May 16, 2018

Northwoods Condominium Association
600 Vail Valley Drive
Vail, Colorado 81657

Subject: Engineering Consultation
Golden Peak Improvements Project
Vail Ski Area
Vail, Colorado
Project No. GS06142.000-145

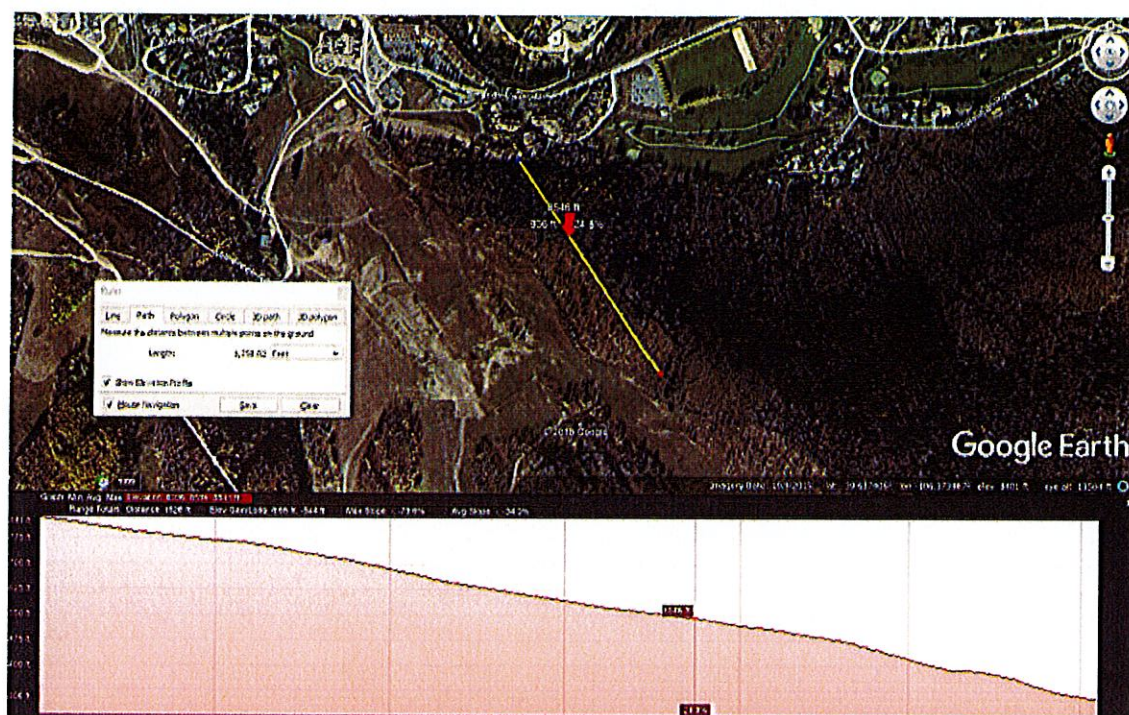
We believe drainage basin GP-2C shown on the plans we reviewed in the LRE report may extend into basin GC-1B and north towards the Town of Vail. Analysis by LRE determined that within drainage basin GP-2C (mogul course) the area covered by snowmaking will change from 7.7 acres to 13.0 acres (59% increase) and water usage will change from 16.5 acre-feet to 24.5 acre-feet (67%). Tree cleared area will change from 18.0 acres to 30.6 acres (59%). LRE in their "Hydrologic Conditions" section of their report state that the above changes will result in increases in total runoff and peak runoff flow.

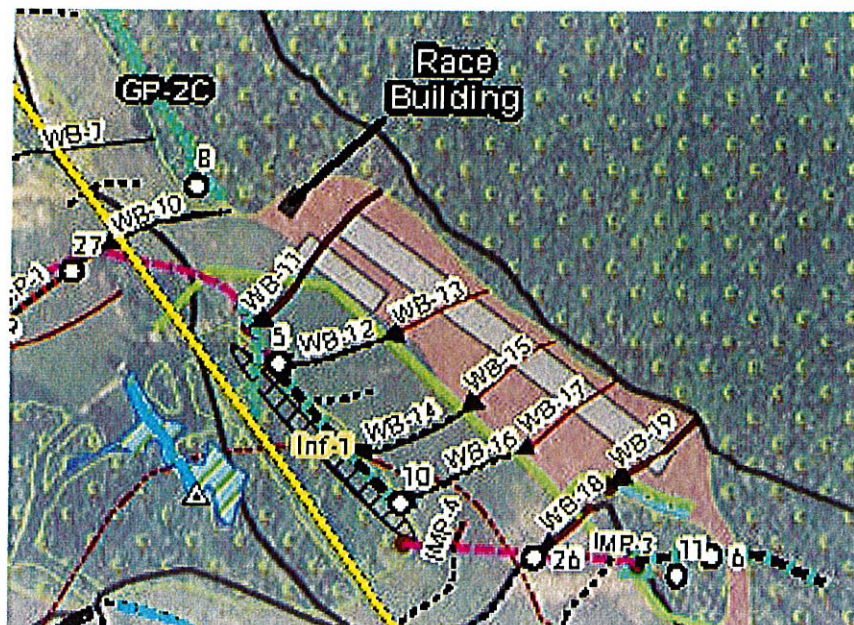
ment loads may be significant, especially if the Golden Peak features are constructed as proposed. A profile of the slope from the bottom of the mogul course to the ridge top above Northwoods is shown below.

This slope profile, generated with Google Earth, indicates that surface and subsurface water at the base of the mogul course is likely to travel to the slopes directly above the Northwoods property. Tree clearing, reshaped surface grades, and additional manmade snow required for the course is likely to increase the amount of surface runoff and subsurface water to the slope directly above Northwoods. This could increase driving forces for slope failures and sediment loads resulting in mudfloods and mudflows.
